Access Compliance Report

Public Rights-of-Way

(Curb Ramps)

Intersection ID: 28438	Main Street: JESSICA_PL	Cross Street: PROSPERITY_VILLAGE_DR	Location: SW
ADA ID: 5CC5A04B296A	Ramp Type: Perp	Initial Pass/Fail: Fail	Overall Compliance: No
			Severity Score: 33.75

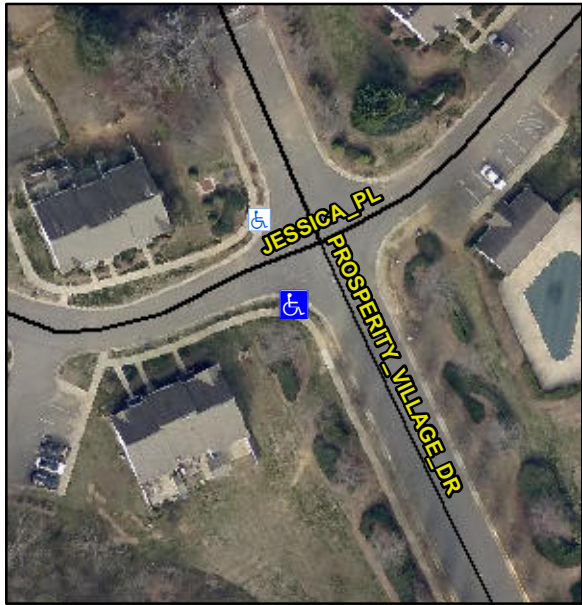
Codes/Mitigation Info/Possible Solution			Field Measurements/Component Compliance					
	Possible Solutions:		Compliance	Description	Data	Compliance	Description	Data
	Remove & Replace Entire Ramp.		N/A	Ramp Length (in)	90.0	No	Ramp Slope (%)	20.0
			No	Ramp Width (in)	46.5	Yes	Ramp XSlope (%)	2.0
			N/A	Flare Type LT	N/A	N/A	Flare Type RT	N/A
			N/A	Flare Slope LT (%)	N/A	N/A	Flare Slope RT (%)	N/A
			N/A	Flare Traversable LT?	N/A	N/A	Flare Traversable RT?	N/A
			N/A	Landing Length (in)	N/A	N/A	DWS Provided?	N/A
			N/A	Landing Width (in)	N/A	N/A	DWS Contrast?	N/A
			N/A	Landing Slope (%)	N/A	N/A	DWS Length (in)	N/A
			N/A	Landing X Slope (%)	N/A	N/A	DWS Full Width?	N/A
Surveyor Notes:			N/A	Landing Curb? (Y/N)	N/A	N/A	DWS Offset (in)	N/A
N/A			N/A	Shared Landing?	N/A			
PROW/ADA:			N/A	Gutter Ponding?	N/A	N/A	Gutter Slope (%)	N/A
R304.5.1, R304.2.2			N/A	Gutter Lip Ht (in)	N/A	N/A	Gutter X Slope (%)	N/A
